Errata Sheet

Product Family:	DL205 / DL305	Date:	September 2018
Manual Number	D2-DCM		
Revision and Date	2nd Edition; February 2003

Page A-4. Point-to-Point RS422 D2–DCM as Master

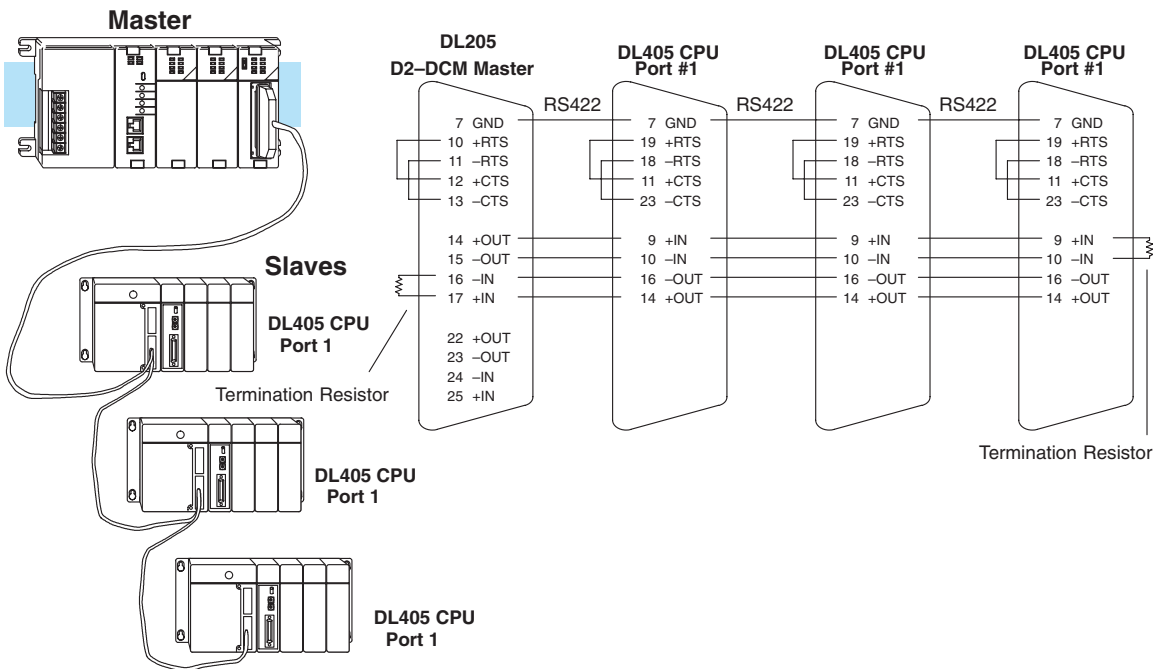
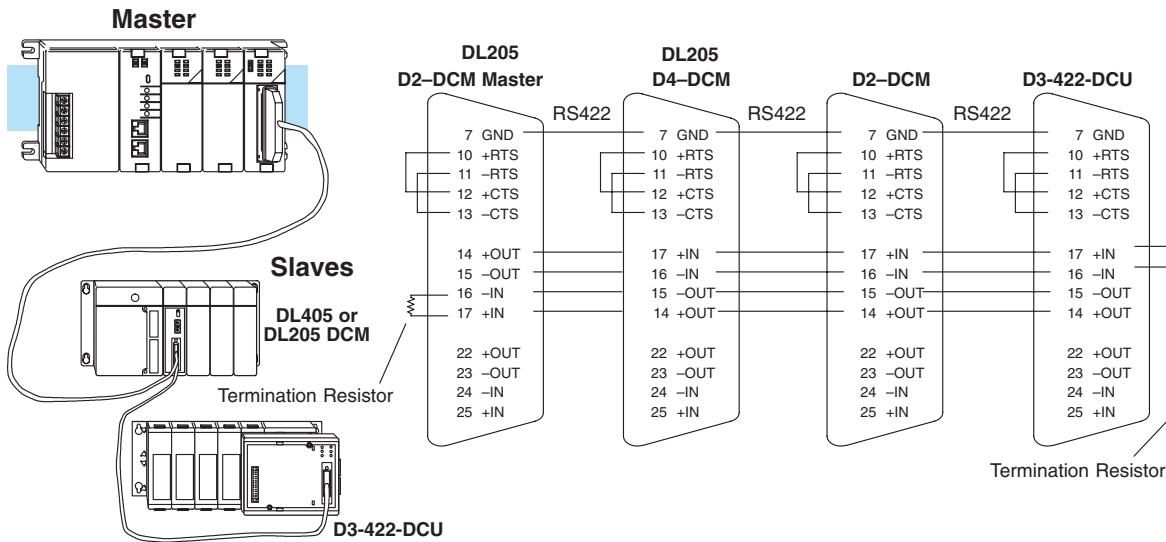
In the lower left drawing there are some pin number errors for the DL405 port 1 25-pin connector. The correct pin numbers are:

19 +RTS (not 10 as shown)

18 -RTS (not 11 as shown)

11 +CTS (not 12 as shown)

23 -CTS (not 13 as shown)

In the top set of drawings, change the callout that says “DL405 CPU Bottom Port” to DL405 Port 1”

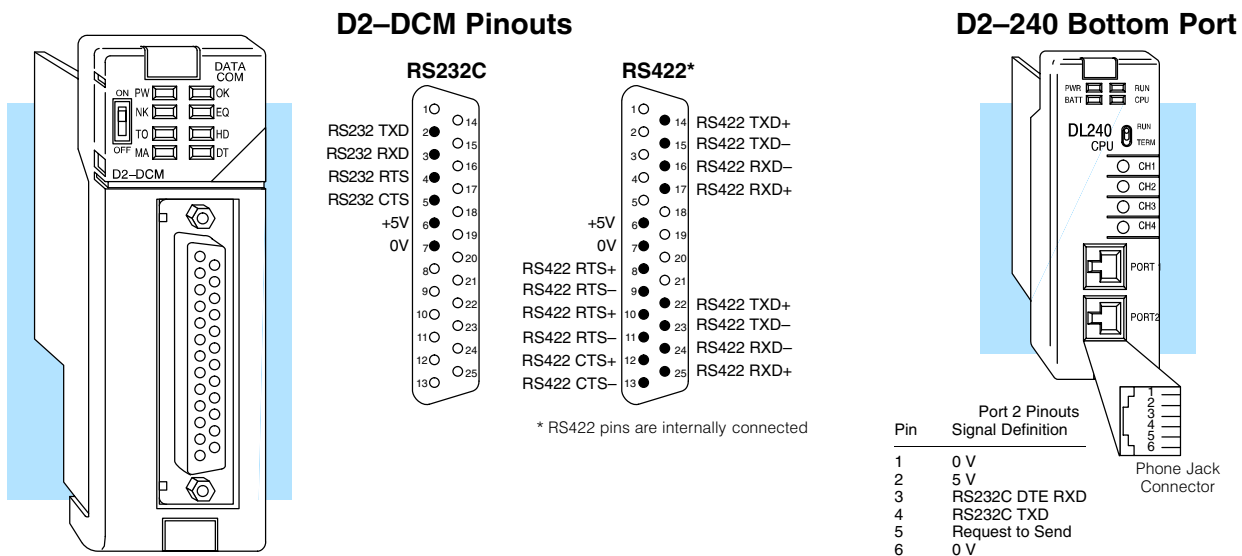
NOTE: ~~The DL205 CPU ports only support RS232C signal levels.~~ If you are going to have more than one slave station, you will have to use RS422 and a FA-UNICON RS232 to RS422 converter for each slave station. See the cable diagrams shown in Appendix A for detailed diagrams.

This note is incorrect. Only the D2-230 and D2-240 CPUs support RS232 only. D2-250(-1) and D2-260 CPUs support RS232/422/485 without extra hardware.

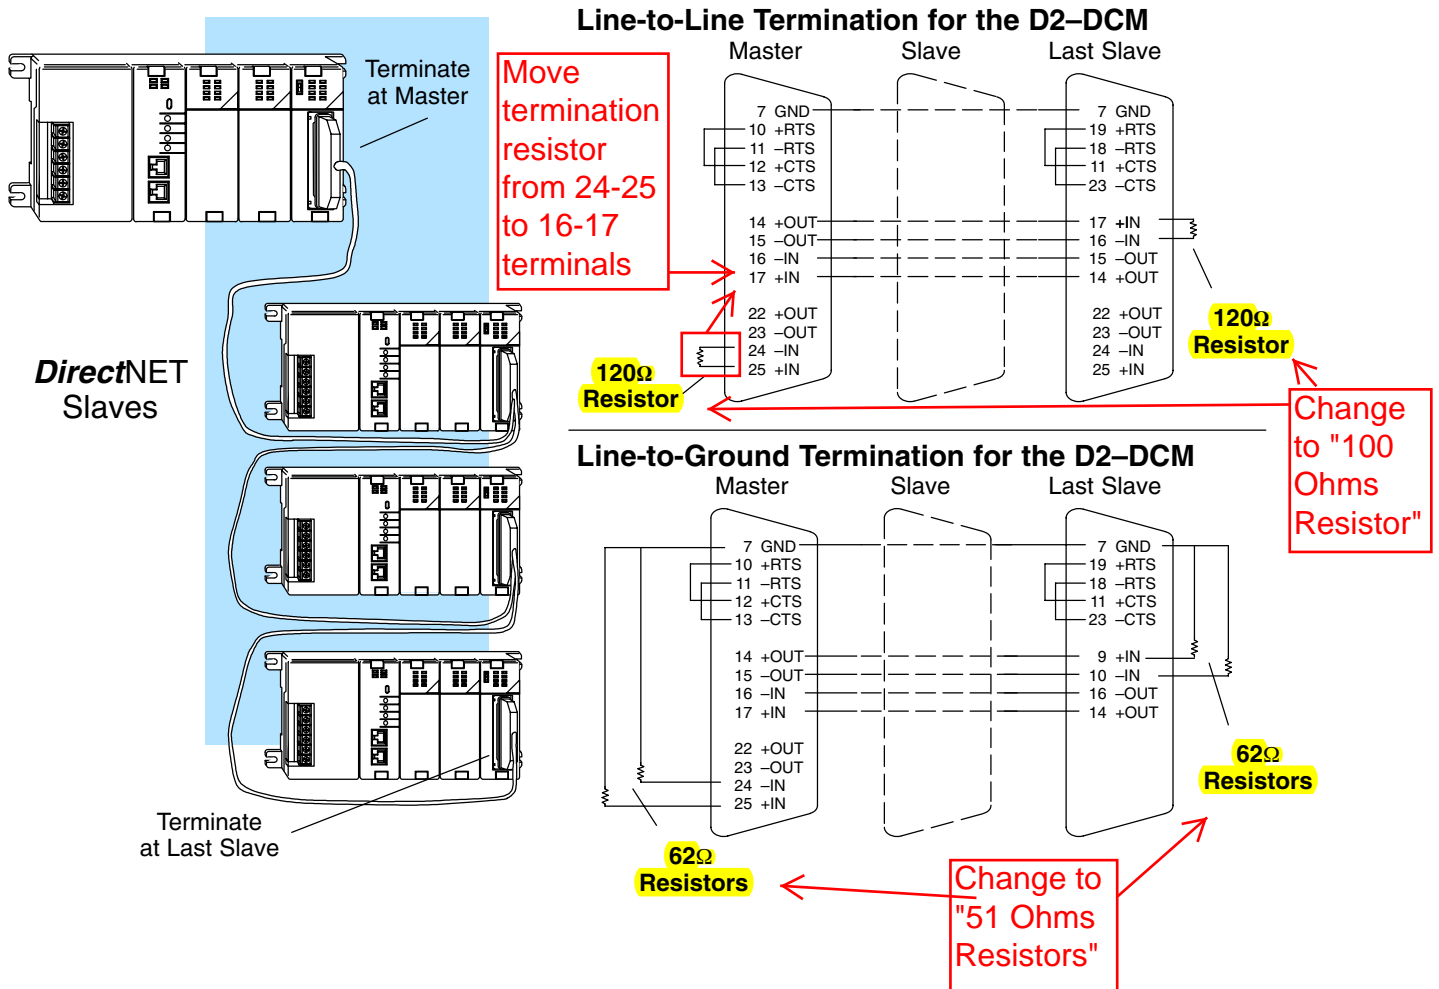
In the top wiring drawing ("Line-to-Line Termination for the D2-DCM"), change both "120 Ohm Resistor" callouts to "100 Ohm Resistor".

In the bottom wiring drawing, change the "65 Ohm Resistors" callouts to "51 Ohm Resistors".

In the top drawing, move the termination resistor on the left connector (Master) from the 24-25 pins to the 16-17 pins.
